**RESOLUTION HOLDING PUBLIC HEARING ON APPEAL BY
QUIK TRIP CORPORATION OF THE CONDITIONS OF A SITE PLAN
FOR PROPERTY LOCATED AT 1501 EAST GRAND AVENUE**

Communication from the City Plan and Zoning Commission advising that at their meeting held February 2, 2017, a request from Quik Trip Corporation (owner) represented by Mike Talcott (officer), for review and approval of an amendment to the Site Plan "Quik Trip No. 0535" under design guidelines for gas stations/convenience stores, on property at 1501 East Grand Avenue, to allow for modification of the approved "urban edge" requirement on the north streetscape of East Grand Avenue and waiver of additional Site Plan design guidelines. (10-2017-7.77)

We have reviewed the first (1st) submittal of the amended site plan for the Quik Trip on E. Grand project, located at 1501 E. Grand Avenue in Des Moines, and have determined that the following conditions must be satisfied before plan approval can be granted.

Store # 0535 Flat Entry Building Elevations
 Serial # 04-0535-BFTI
 Scale: 1/8"=1'-0"
 Issue Date: 05.10.16

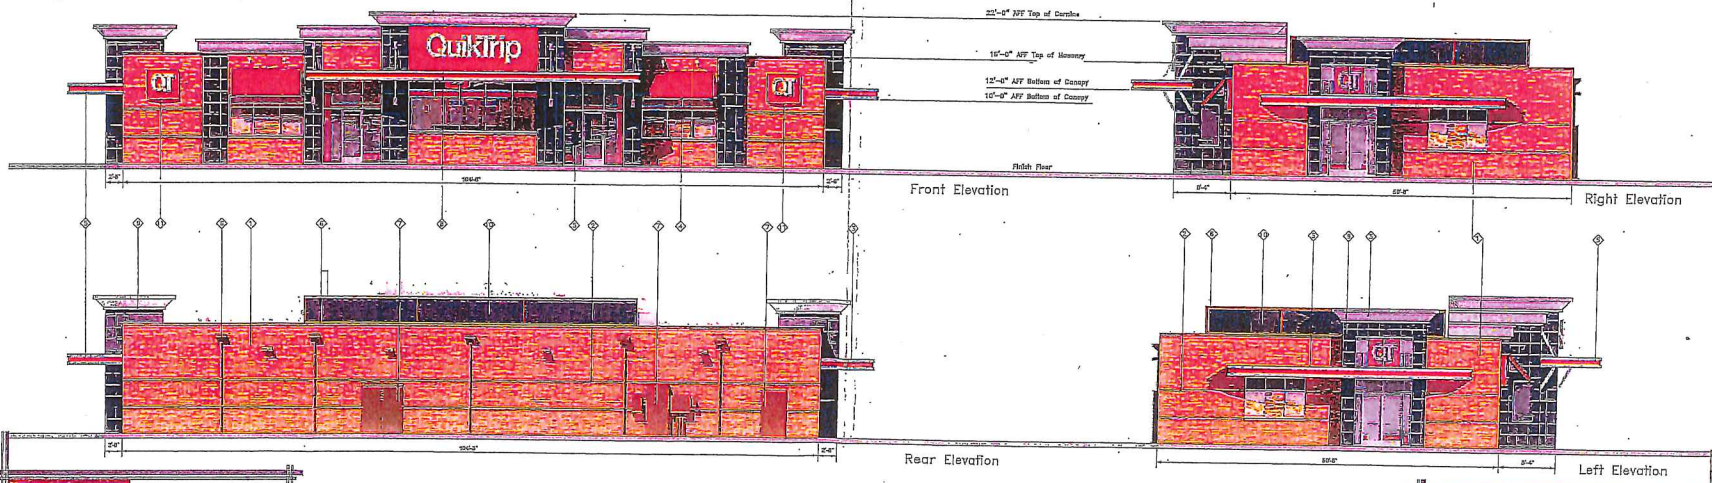
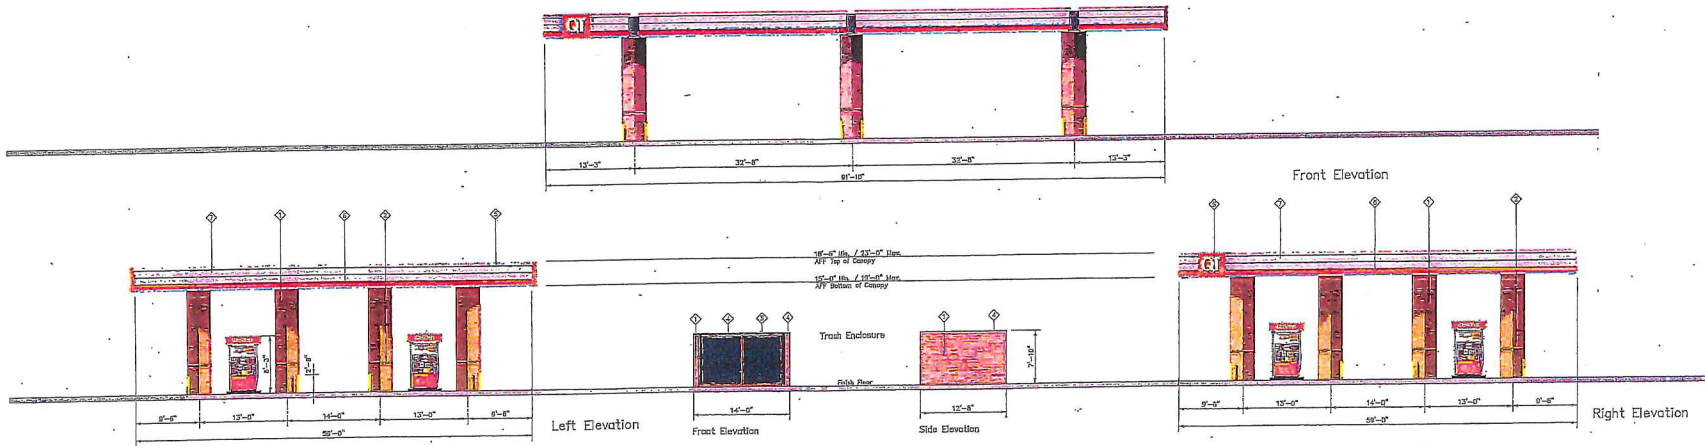
11. Deficiency in identification of all building mounted light fixtures as cut-off.
12. Deficiency in all sides of the building showing consistent architectural character (porcelain elements should be provided on the rear façade along with cornice design to match the other three facades).
13. Traffic and Transportation Division's request to remove the commercial access on Capitol Avenue has not been satisfied.

The north, west and south facades of the proposed building would be sided with brick and porcelain tile and would have aluminum cornices and entrance canopies. The east rear façade would be sided with brick. Because of the site elevation, the rear side of the building will have exposure to westbound traffic on East Grand Avenue. Staff recommends that the elevations demonstrate significant architectural detailing on all four facades.

- D. All sides of a building should express consistent architectural detail and character, with a primary use of durable materials such as brick, masonry block, or in special instances a predominant material found in the surrounding commercial area. Columns should be designed to minimize visual impact.**

- j. Utilizing cut-off light fixtures for all building mounted lighting.
 - k. Providing consistent architectural detail on all sides of the building including porcelain elements and cornices on the rear façade that match the other three facades.

- k. Providing consistent architectural detail on all sides of the building including porcelain elements and cornices on the rear façade that match the other three facades.
- l. Removal of the commercial access drive on to Capitol Avenue.
